2nd Revised Response to Request for Additional
Information No. 841-6055 Revision 3

US-APWR Design Certification

RAI NO.: NO. 841-6055 REVISION 3
SRP SECTION: 03.04.01 – INTERNAL FLOOD PROTECTION FOR ONSITE EQUIPMENT FAILURES
APPLICATION SECTION: 3.04.01
DATE OF RAI ISSUE: 10/18/2011

QUESTION NO.: 03.04.01-29:

Figure 9.3.3-1 Equipment and Floor Drain System Flow Schematic Radiological Controlled Area (Sheet 2 of 2)

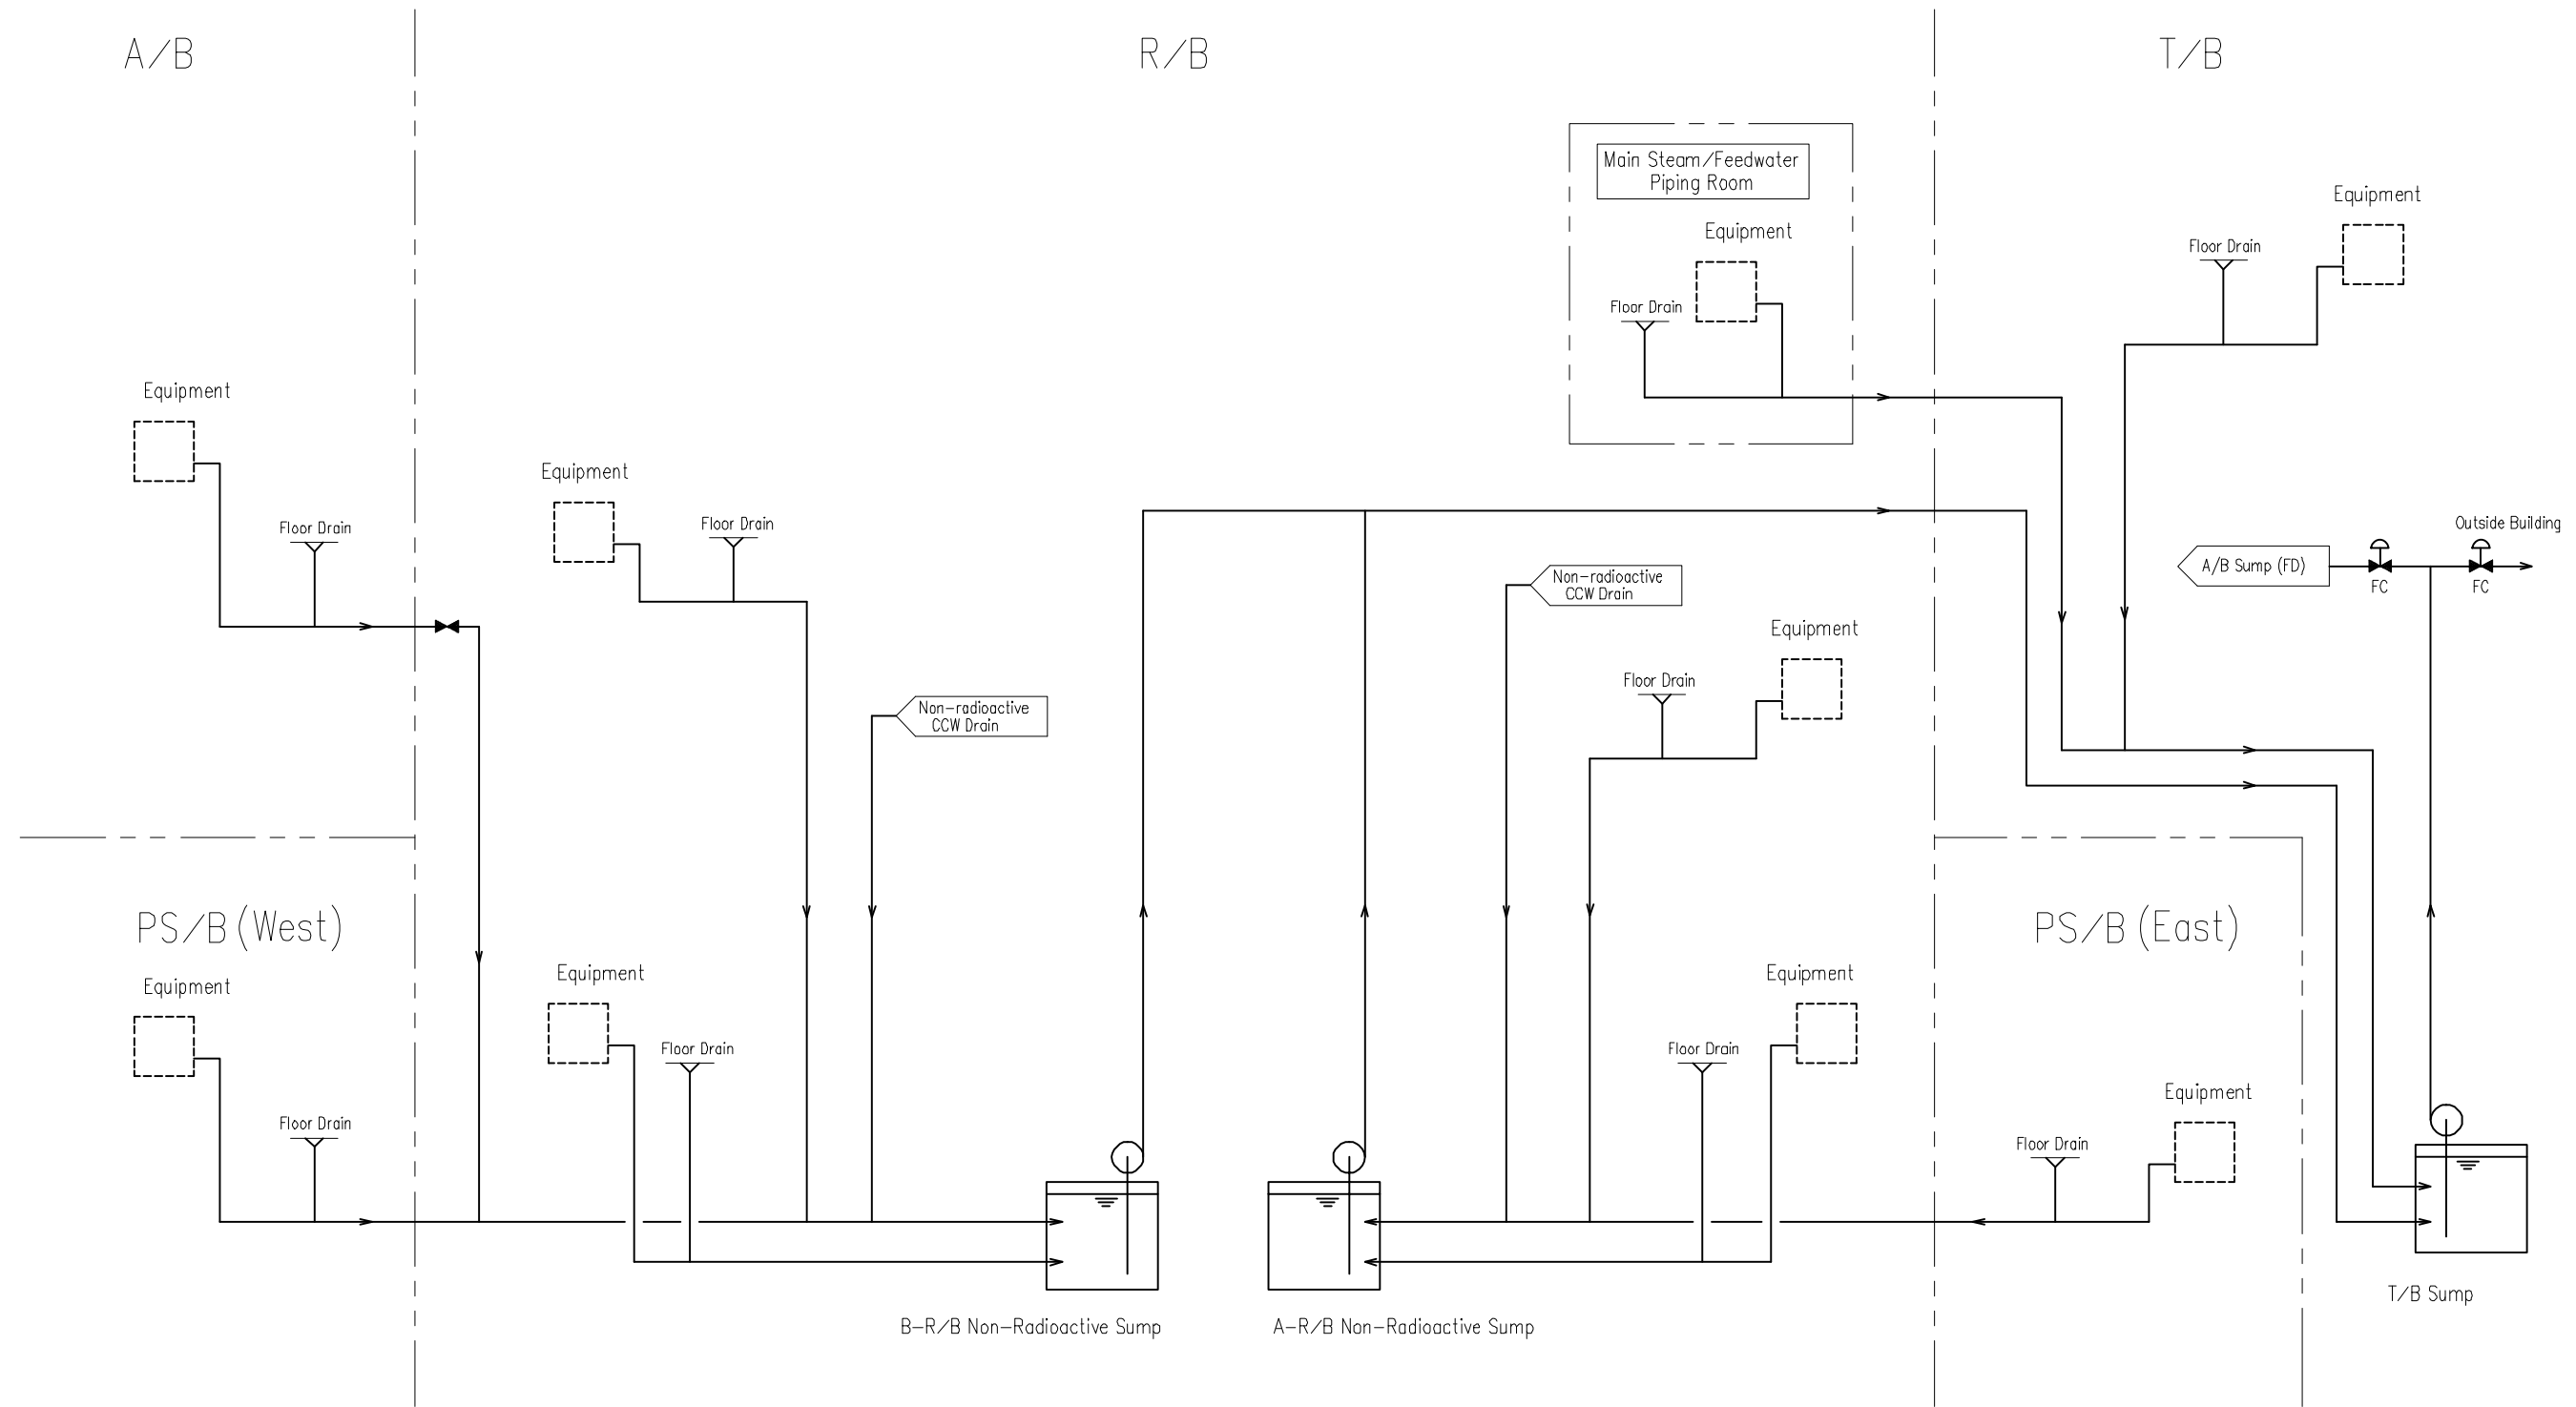
The DCD Tier 2 Section 9.3.3 and Figure 9.3.3-1 are revised to illustrate the isolation valve in non-radioactive drain line from the A/B to the R/B.
